Rezoning Application: RZ-PD 25-1244

**Hillsborough
County** Florida

Development Services Department

The applicant is requesting to rezone the property from ASC-1 to Planned Development (PD) to allow for commercial uses.

FIGURE 1
ACCESS SPACING

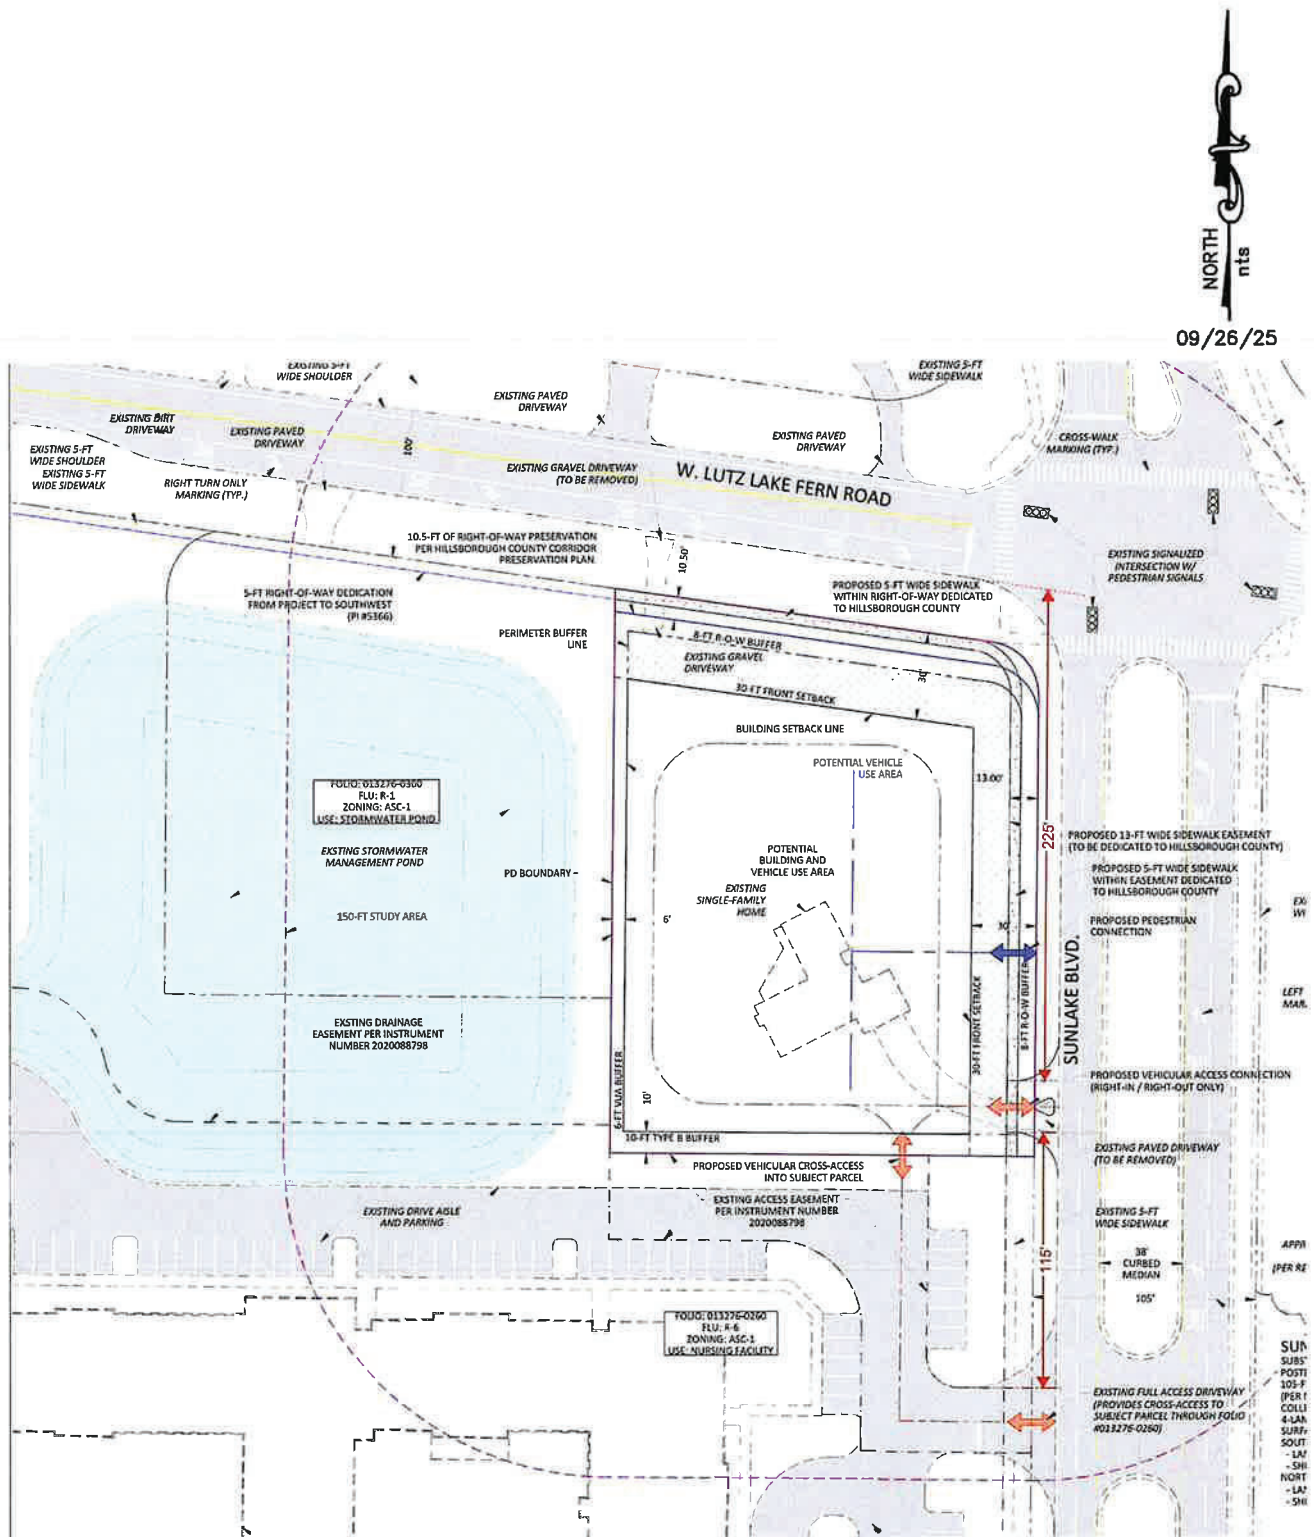
The request is for an Administrative Variance to Section 6.04.07 of the Hillsborough County LDC for the access spacing on Sunlake Boulevard. Based on Section 6.04.07, the access spacing on Sunlake Boulevard is 245 feet. The distance to the driveway is 225 feet from Lutz Lake Fern Road and 115 feet from the access to the Pruitt Health Facility. This is graphically shown in Figure 1.

The applicant's Engineer of Record (EOR) has submitted a Section 6.04.02.B. Administrative Variance Request (dated and submitted September 29th, 2025) from the Section 6.04.07 LDC requirement governing spacing for the proposed Sunlake Blvd. access. In accordance with this section of the LDC, Sunlake Blvd. has been identified as a Class 5 roadway with a posted speed limit of 45MPH. As such, the minimum connection spacing is 245ft. The applicant is proposing the driveway in a location which is +/- 115ft from the adjacent driveway to the south. As such, the applicant is seeking a variance of 130ft. Based on factors presented in the Administrative Variance Request, the County Engineer found the request approvable on November 7th, 2025.

If this rezoning is approved by the BOCC, the County Engineer will approve the above referenced Administrative Variance Request.
